<b>HYUNDAI</b> <b>Technical Service Bulletin</b>	<b>GROUP</b> <b>AUTOMATIC TRANSMISSION</b>	<b>NUMBER</b> <b>23-AT-008H-1</b>
	<b>DATE</b> <b>SEPTEMBER 2023</b>	<b>MODEL</b> PALISADE (LX2) SANTA FE (TMA) SANTA FE HYBRID (TM HEV) SANTA FE HYBRID (TMA HEV) SONATA (DN8/DN8A) SONATA HYBRID (DN8 HEV) TUCSON (NX4/NX4A) TUCSON HYBRID (NX4 HEV)
<b>SUBJECT:</b> <p style="text-align: center;"> AUTOMATIC TRANSAXLE (8-SPEED FWD)  POSITION SENSOR DTC P070500, P070512, P070514,  P07051C, P070600, P070661 &amp; P070696 DIAGNOSIS AND  REPLACEMENT </p>

***This TSB supersedes TSB 23-AT-008H to add harness information for Tucson (NX4/NX4A), Step 7.***

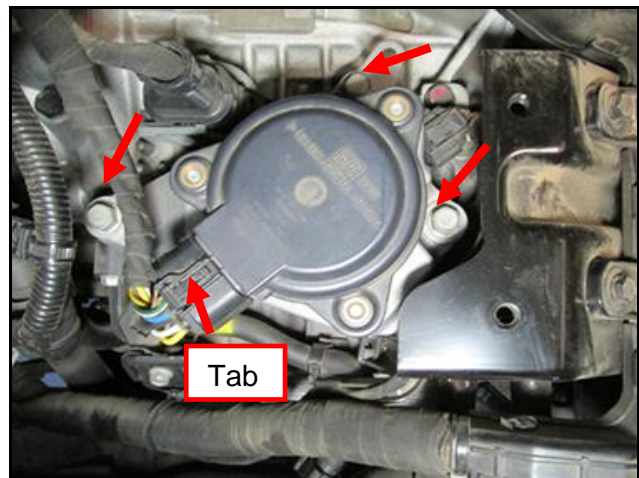
**Tucson (NX4/NX4A) 2.5L –VINs KM8 or 5NM**  
Carefully unwrap the harness protector in the areas shown below:  
1. Check if the insulation has been damaged by contact with the metal bracket.  
2. Check for broken wires in the area of the 90 degree bend in the harness.  
If so, repair or replace the control harness.

If replacing the control harness, make sure the replacement harness does not contact the battery tray/other components. Otherwise, the harness may become damaged again.
